VARIANCE APPLICATION

SEPTIC SITE PLAN / VARIANCE PLAN
1113 RIDGE PLACE
PLAT OF SUNRISE BEACH SECT 4
LOT 1113
ZONING R2

**RE: Variance Application – Explanatory Letter
1113 Ridge Place, Crownsville MD, 21032
Plat of Sunrise Beach, Section 4, Lot 1113
Tax Map 31 Block 16, Parcel 146**

CONFIRMATION OF PRE-FILE MEETING

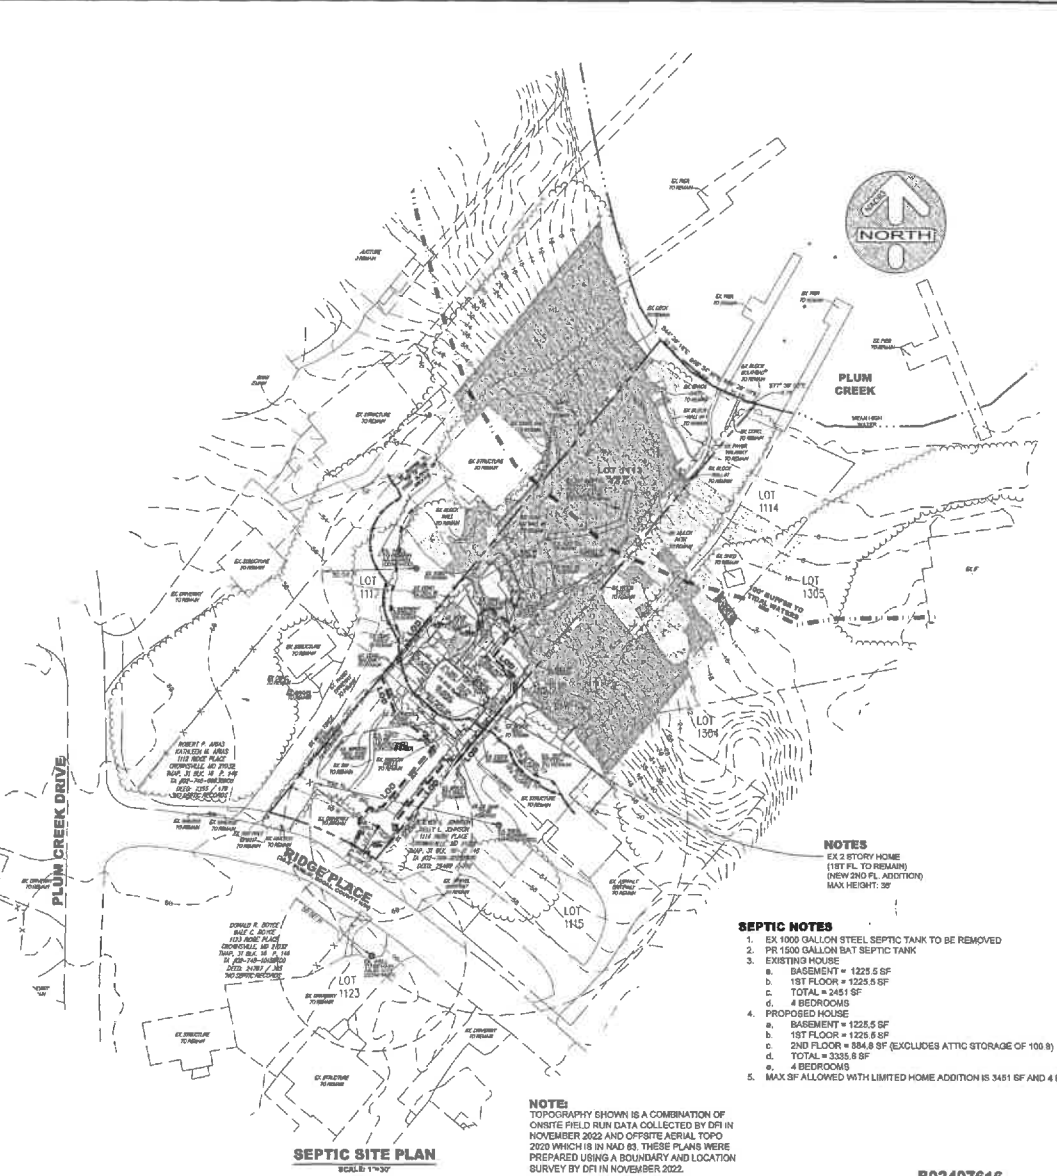
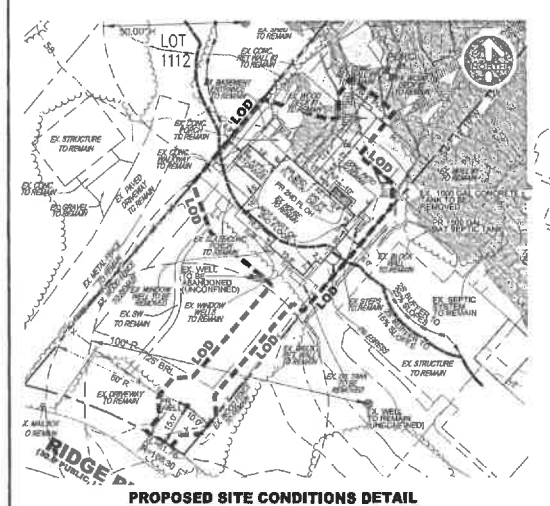
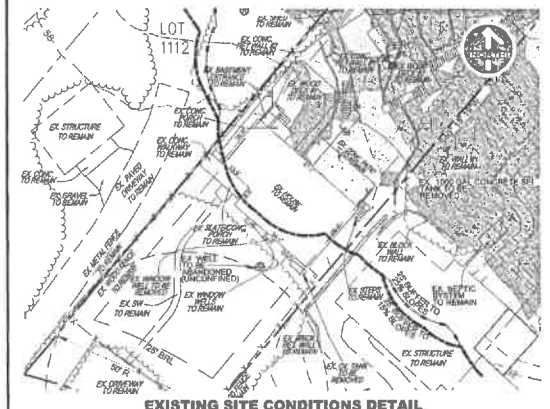
Comment: The variances required are to setbacks and steep slope disturbance. Include the height of the finished structure on the site plan in the location of the structure. A modification will be required for steep slope disturbance as well.

Response: The height of the structure is noted on sheet 1, max height 36'.
